A. ADMINISTRATIVE REPORT & DECISION

Project Name: Stewart Short Plat

File Number: LUA16-000464, ECF, SHPL-A

ADVISORY NOTES TO APPLICANT

LANDSCAPE PLAN

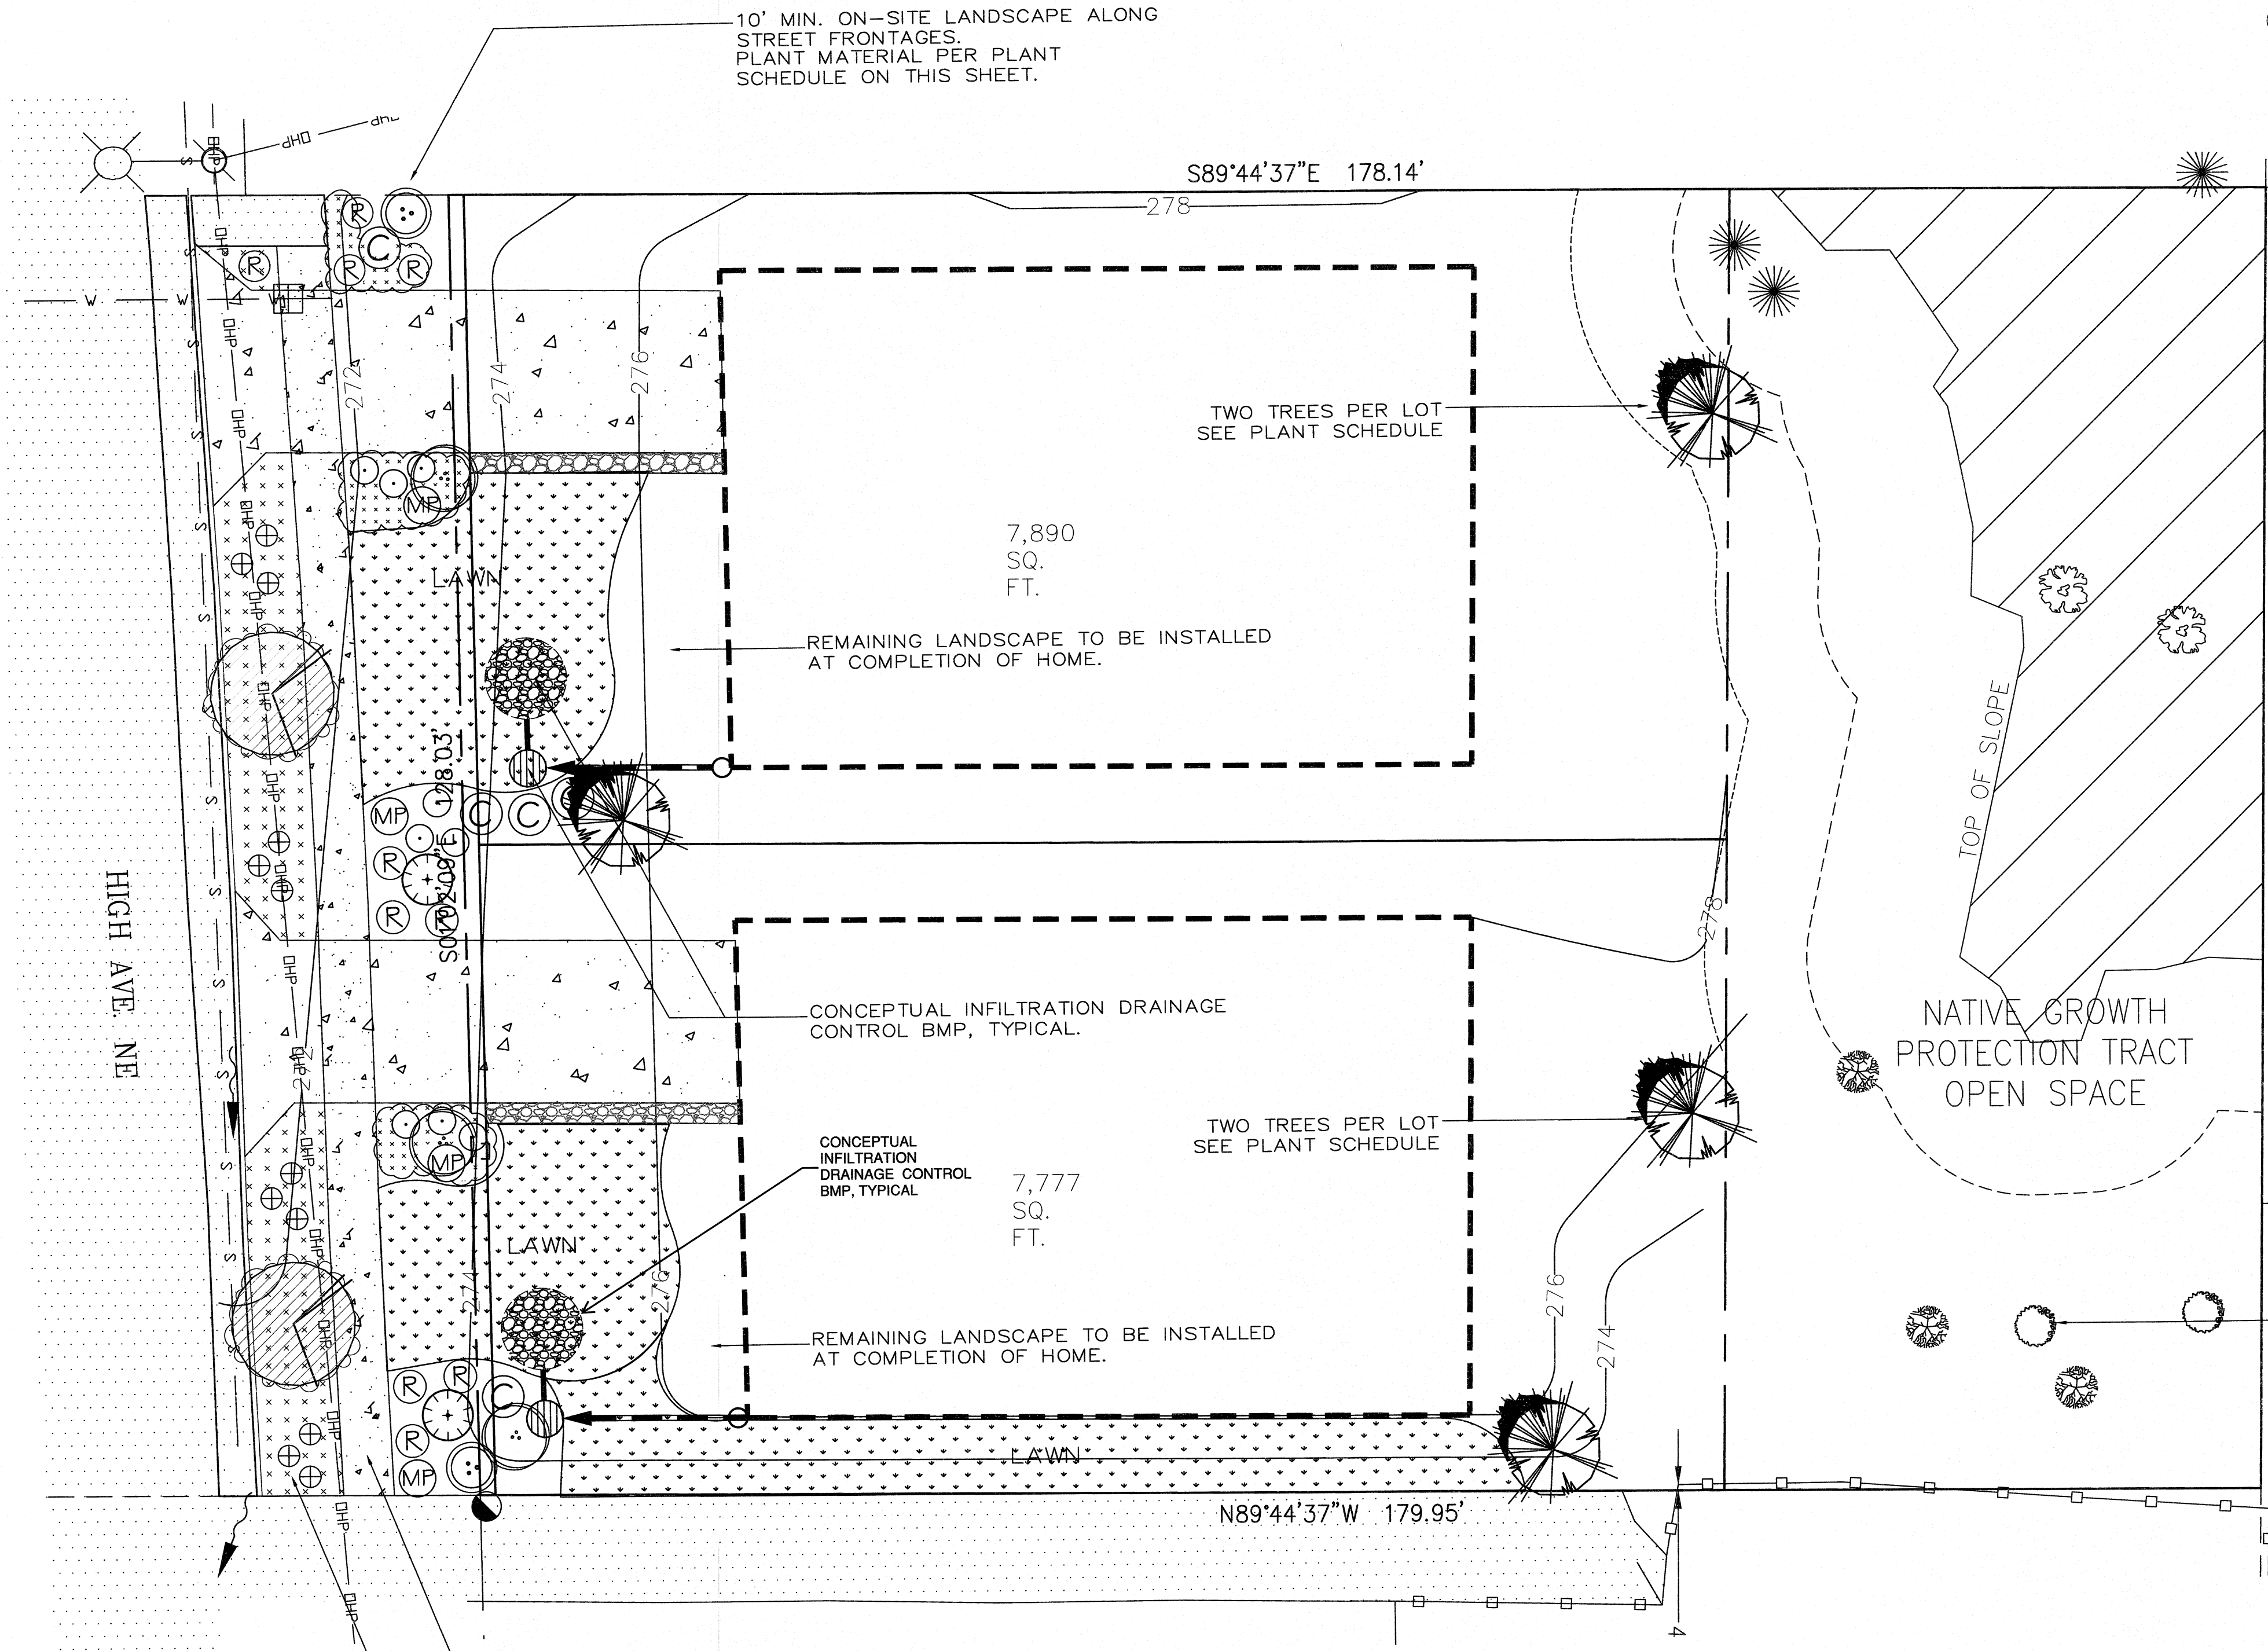
3. A detailed landscape plan shall be submitted with the Utility Construction Permit application showing the minimum 8-foot landscape strip between the curb and sidewalk and the minimum 10-foot on-site landscape strip required within the front yard areas of the proposed lots. The detailed landscape plan shall be submitted to the Current Planning Project Manager for review and approval. Landscaping between the curb and sidewalk shall be installed prior to final short plat approval, landscape behind the sidewalks shall be installed and inspected prior to Certificate of Occupancy for the new homes.

4. A 10-foot wide landscaped visual barrier shall be planted along the north property line of Lot 1 and the south property line of Lot 2, this landscaped visual barrier shall be protected within a 10-foot wide easement. The easement shall be recorded on the face of the final short plat. The plantings for the landscaped visual barrier shall be included on the detailed landscape plan and shall be submitted to the Current Planning Project Manager for review and approval at the time of Utility Construction Permit review. The plants shall be installed and inspected prior to Certificate of Occupancy for the new homes.

TREE RETENTION / LAND CLEARING PLAN

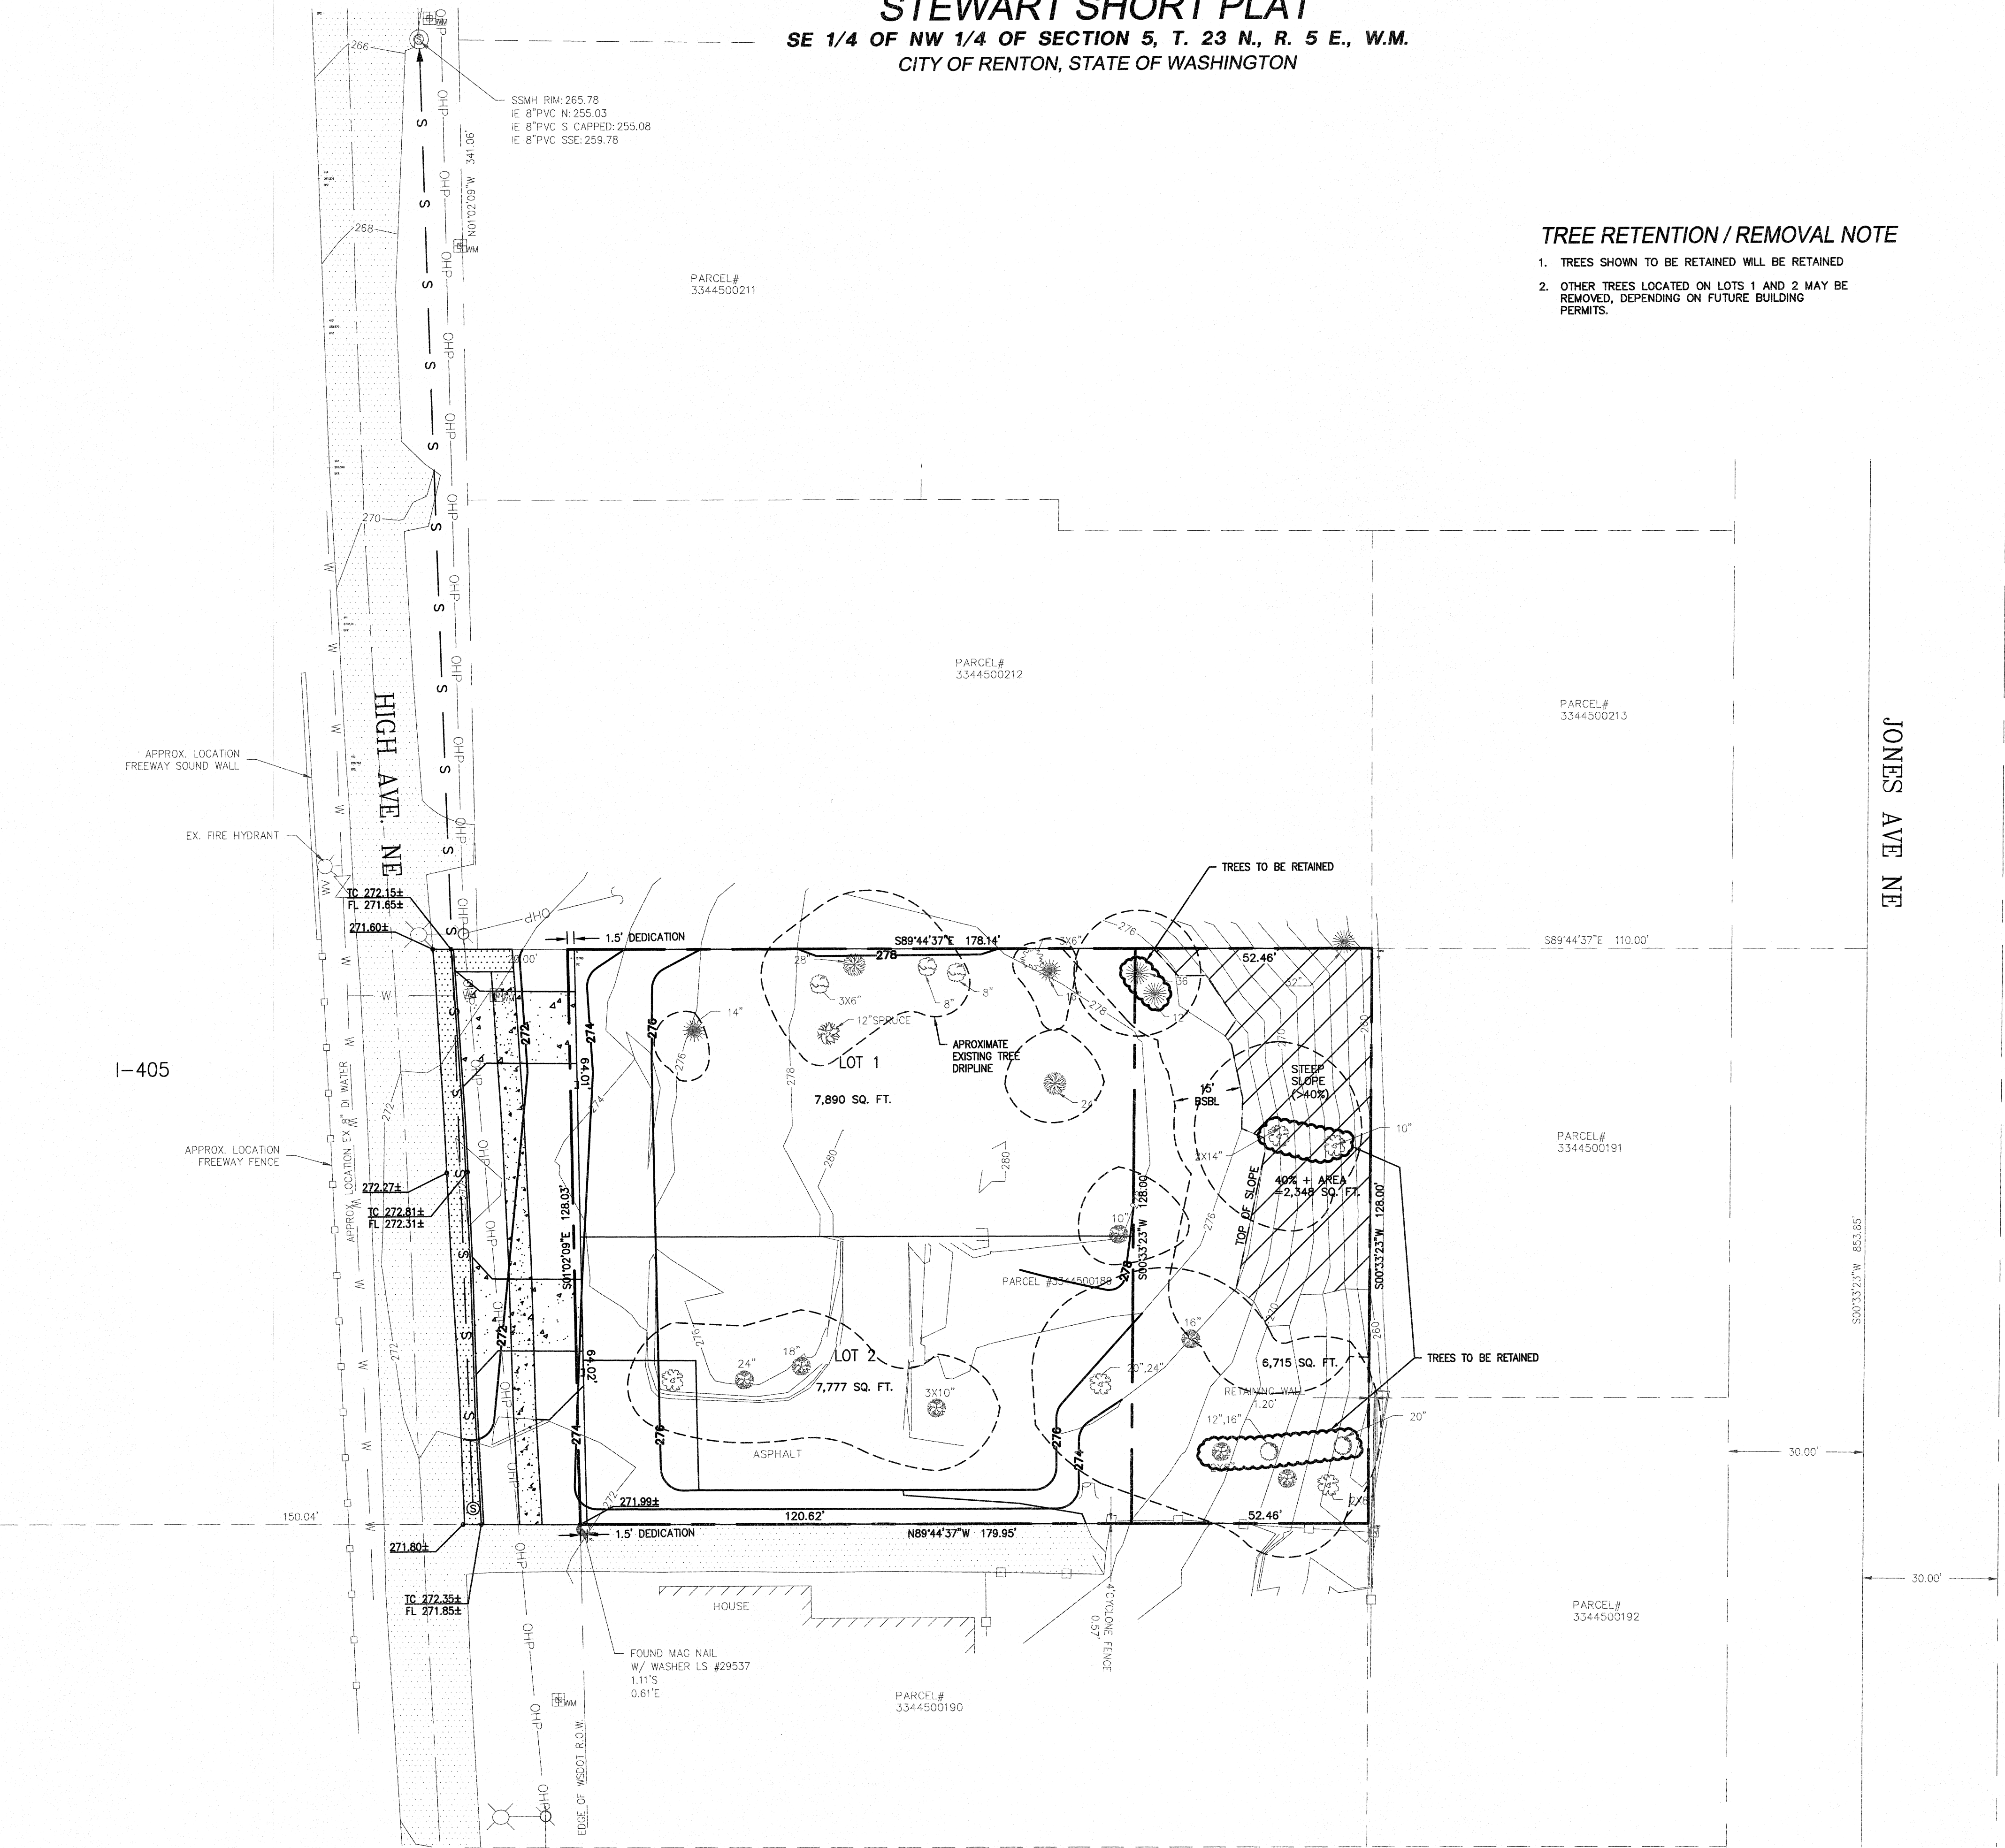
5. A Final Tree Retention and Land Clearing Plan shall be submitted at the time of Utility Construction Permit review. The Final Tree Retention and Land Clearing Plan shall include the retention of three additional trees (trees 106, 107, and 109) in addition to the 5 trees currently proposed for retention, resulting in a total of 8 retained trees. The final tree retention plan shall be submitted to the Current Planning Project Manager for review and approval prior to the issuance of the Utility Construction Permit.
